**ADDENDUM TO THE MITIGATED NEGATIVE DECLARATION FOR THE
MONK HILL TREATMENT SYSTEM PROJECT LOCATED AT 2696 WINDSOR AVENUE,
PASADENA, CALIFORNIA**

REVISED PROJECT DESCRIPTION:

Temporary Pipeline Layout

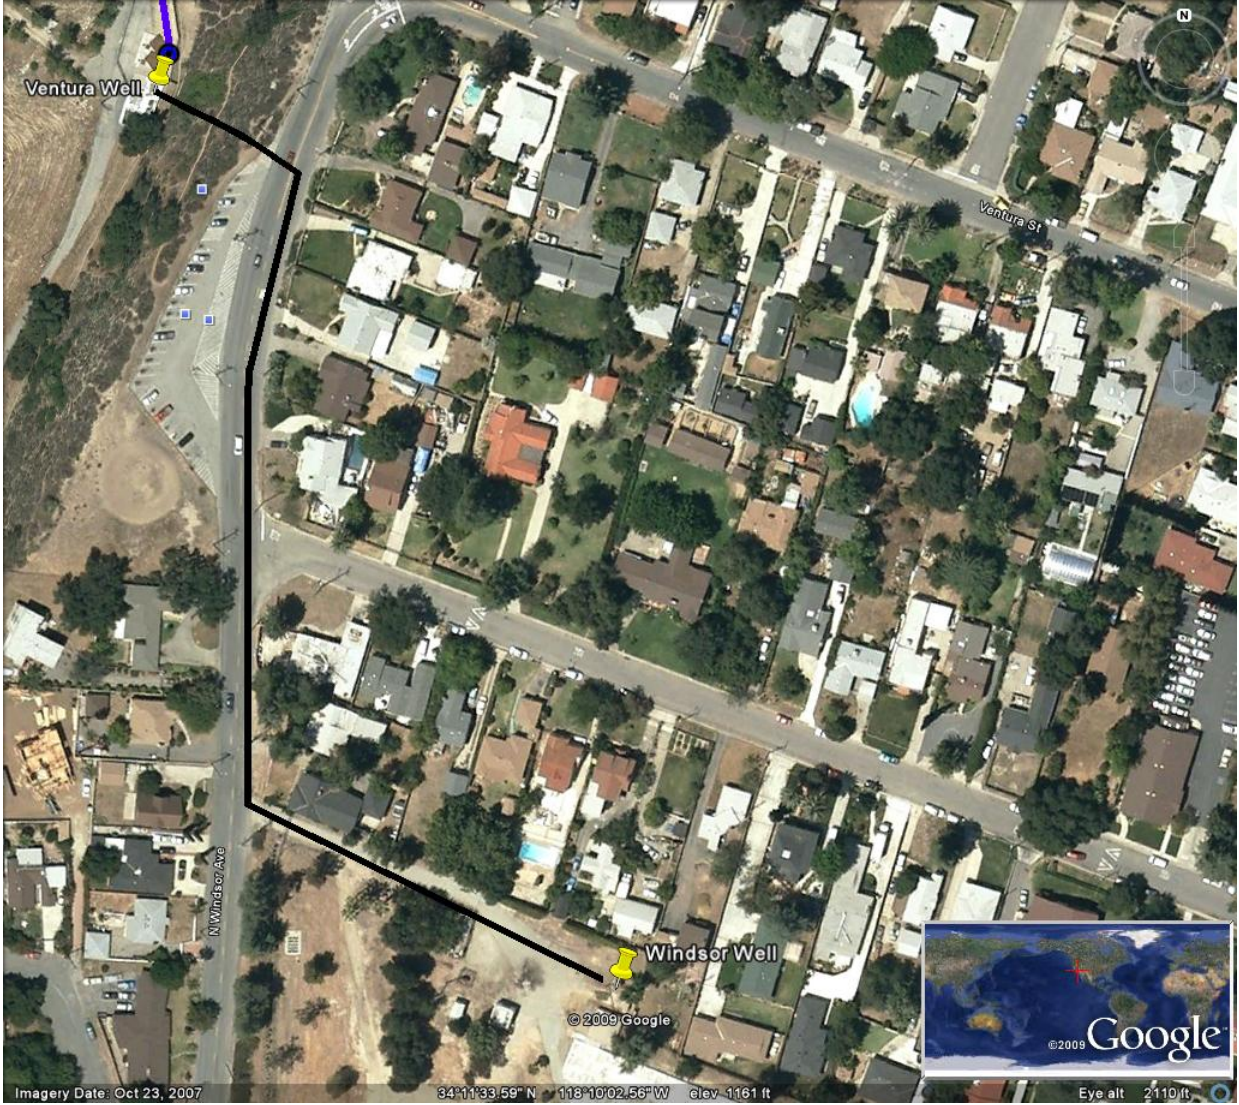
Development water from each of the wells would be transferred to the JPL OU-1 system for treatment via existing below-ground piping (i.e. from the Windsor well to Ventura sump) and approximately 5,300 ft of temporary above-ground 4-inch-diameter piping (i.e. extending from the Ventura sump to the OU-1 treatment system) to be installed as part of this project.

A second 4-inch pipeline will be installed connecting Arroyo, Well 52, and Ventura wells to the Ventura sump. The second pipeline will have an approximate length of 1,400 feet. This pipeline will allow water to be transferred from the three wells to the Ventura sump prior to being pumped to the OU-1 treatment system.

Figure 1 (see attachment) shows the 5,300 foot temporary pipeline layout, swale, road, and bridge crossing. The attachment contains detailed routing locations for the temporary piping. The second 1,400 foot pipeline from Arroyo to Ventura well sites will be placed adjacent to the 5,300 foot temporary pipeline.

Pipelines will be buried beneath high traffic areas located off the JPL property. The trench for the pipe will be cut approximately 12" to 18" in width and 18" to 24" in depth. The fill will be compacted and leveled to the adjacent roadway. At the completion of the initial well cleaning, all temporary pipelines and supporting hardware will be removed from the property, pipeline trenches will be backfilled, compacted, and the surface restored to the City Public Works' requirements.

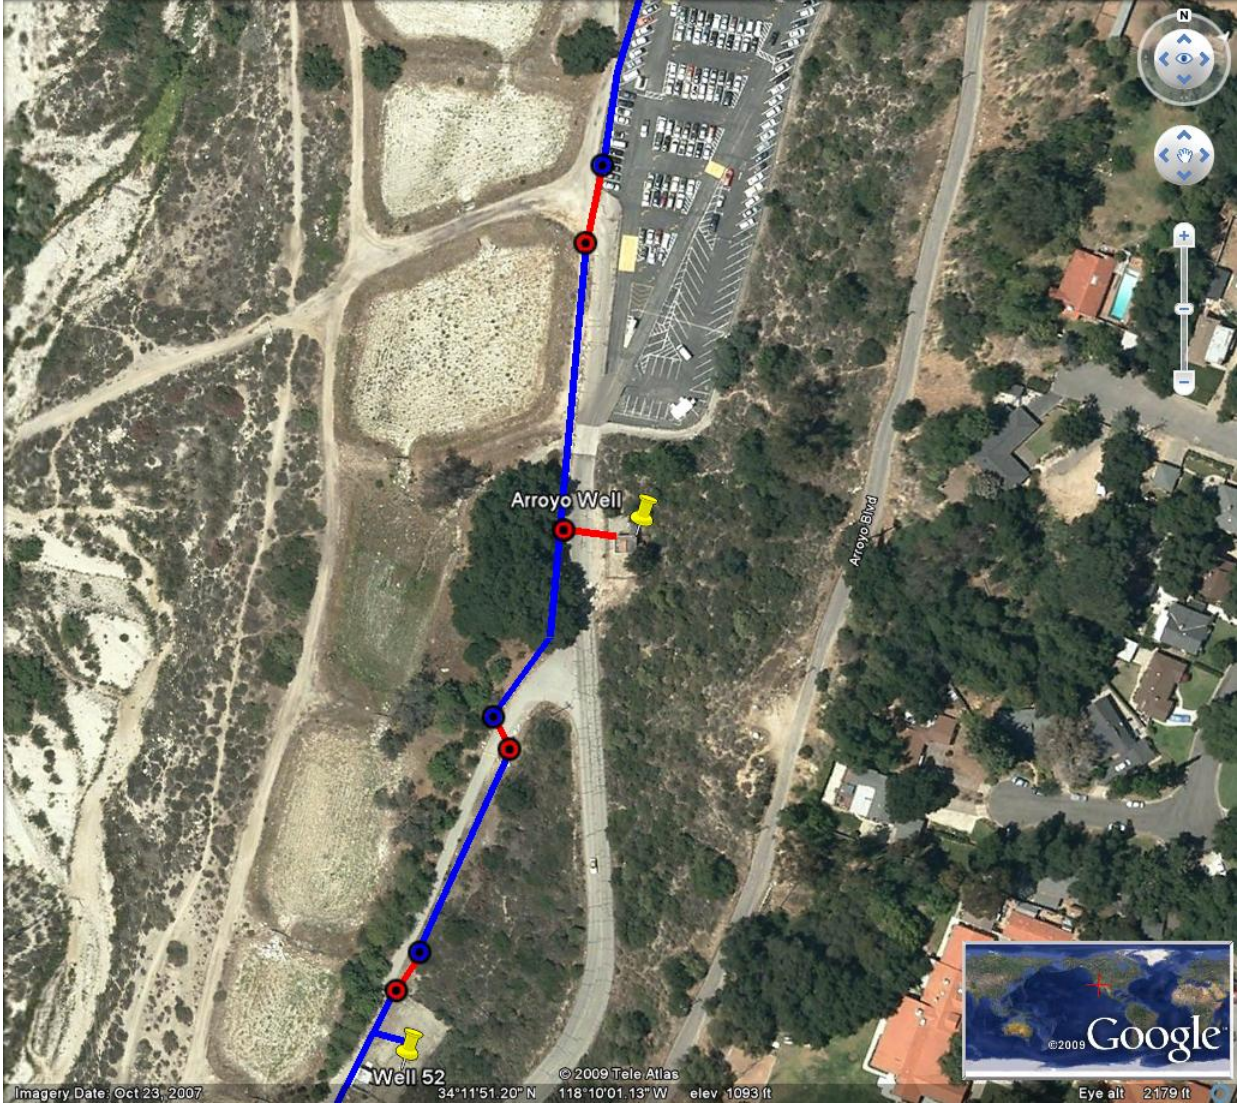
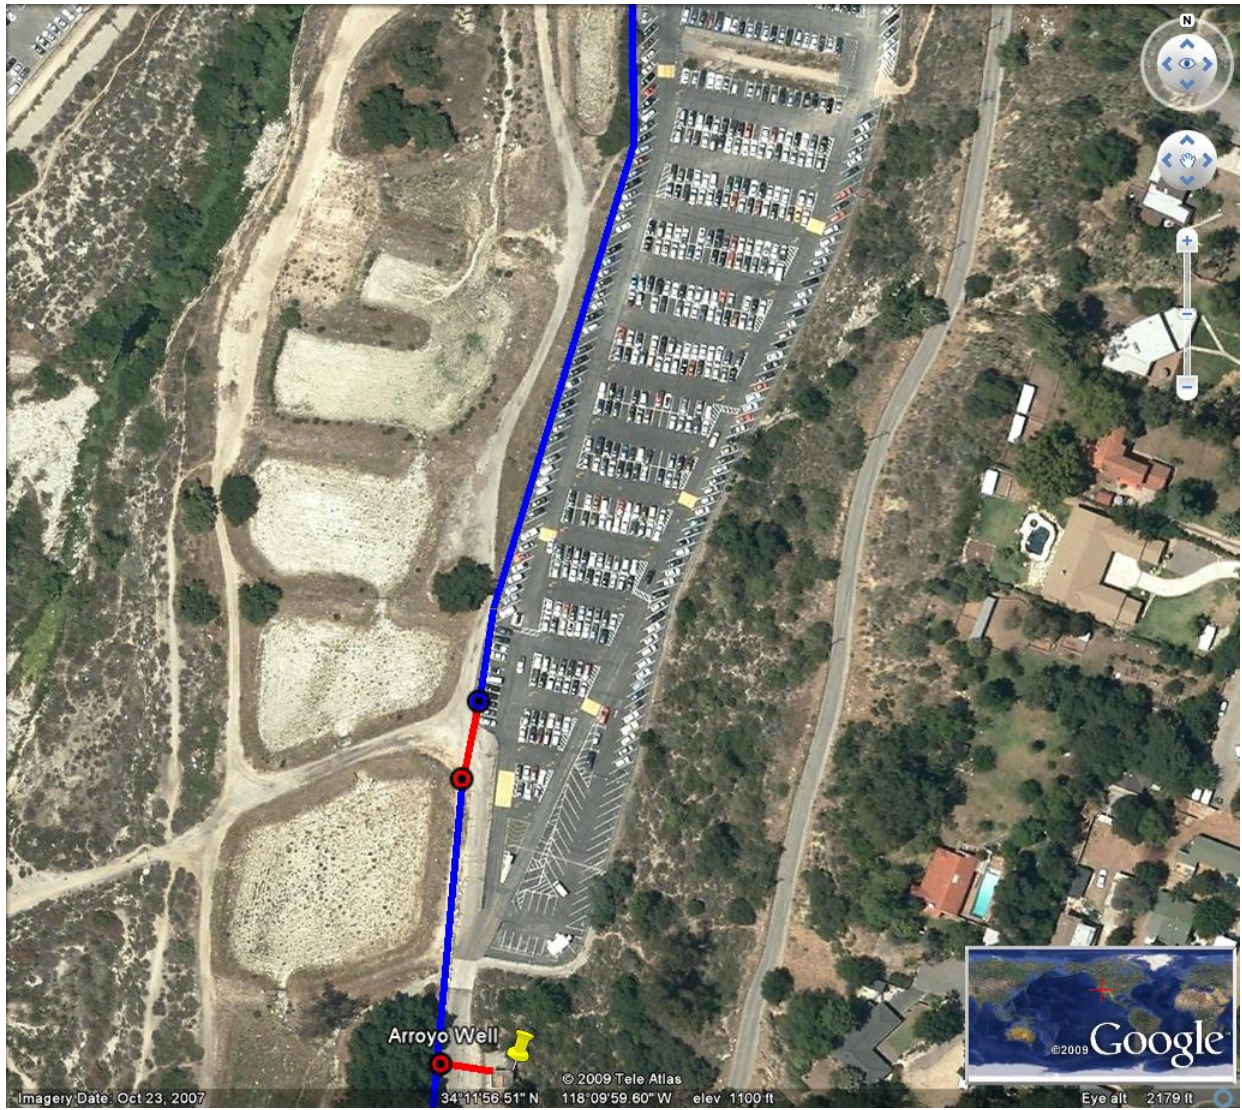
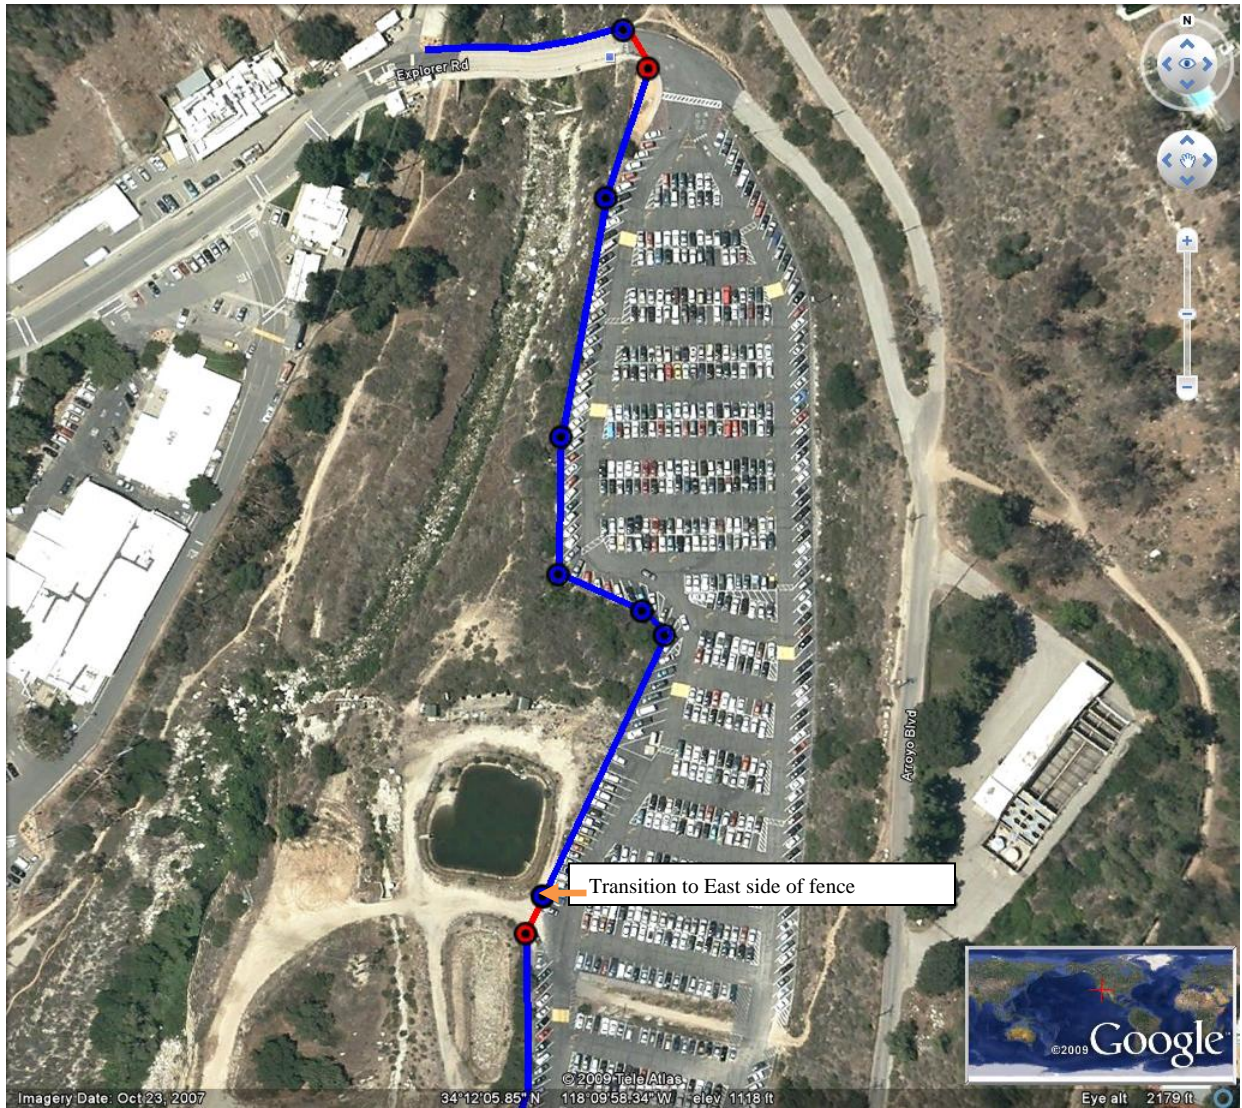
*Red Pipeline sections are the proposed locations where the pipeline will need to go underground for vehicle crossings.

Black line indicates existing underground piping to be utilized

*After the road crossing the pipeline will need to transition to the east side of the fence so as to not impact the native plant habitat.
